We have reviewed the draft report, "Corrosion Behavior Of Low Carbon Steel in High pH Aqueous Media", and have indicated our comments on the enclosed markup. Some are editorial in nature, but others are intended to focus attention on our interest in more specificity as to findings, conclusions and recommendations. Thus:

Corrosion Behavior of Low Carbon Steel in High pH Aqueous Media

Figure 1. Cyclic anodic polarization curve for A27 steel in GR-4 water at 95°C.

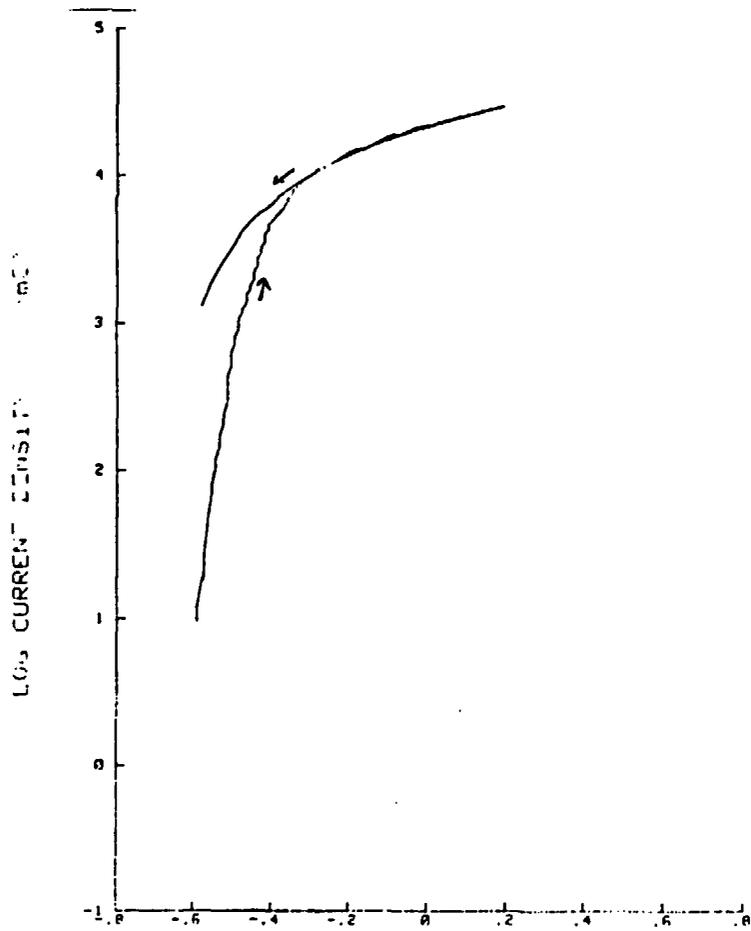
opinion?
of what?
with same smooth.

not
at least

the explanation

Figure 2. Cyclic anodic polarization curve for A27 steel in GR-4 water with basalt and bentonite at 95°C.

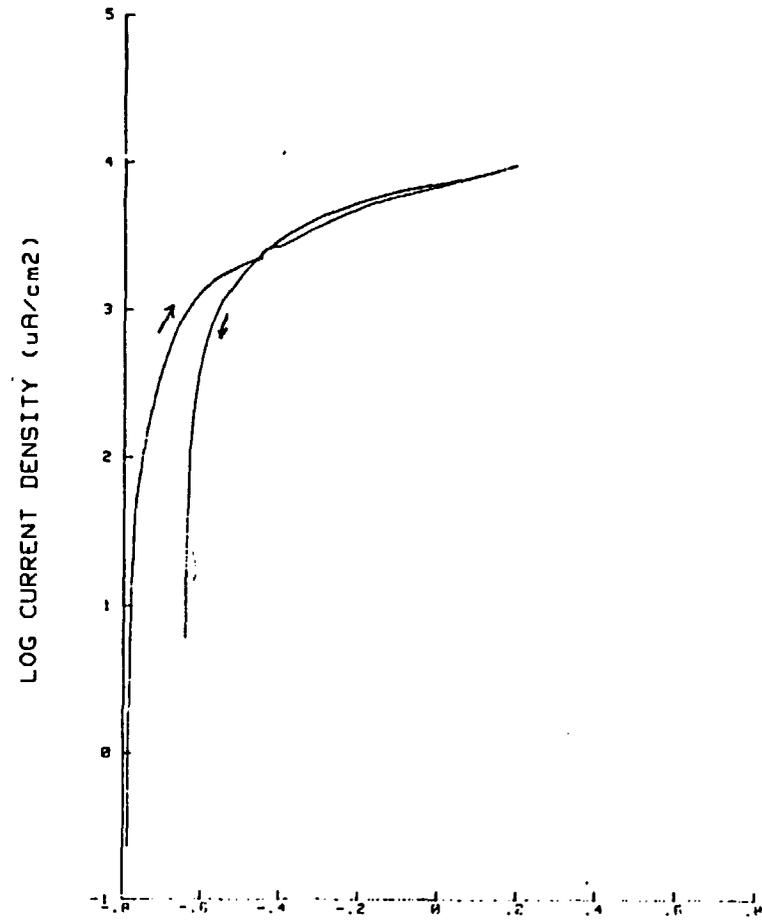
opinion?
should reconcile with Fig 1 explanation

Fig. 5. A27 steel, anodically polarized, (cyclic).

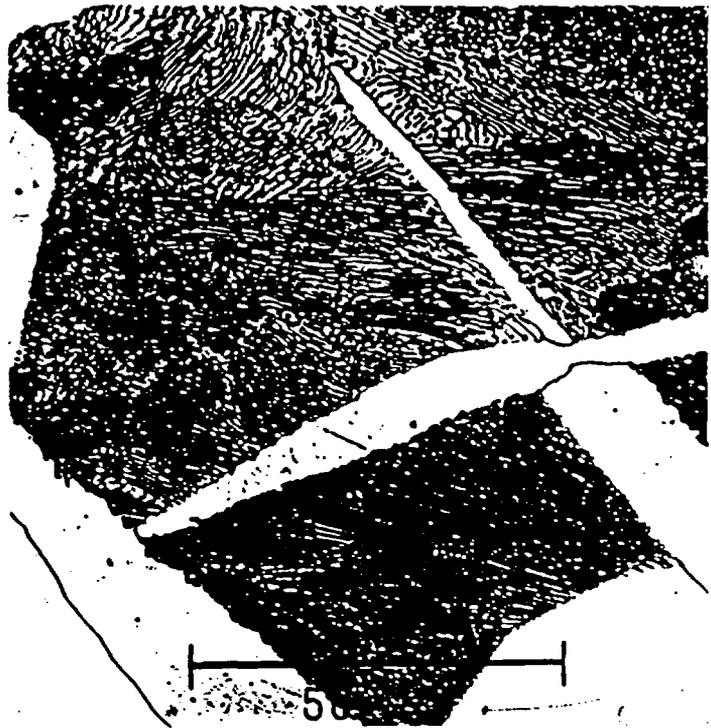
can't see in picture

define pit.
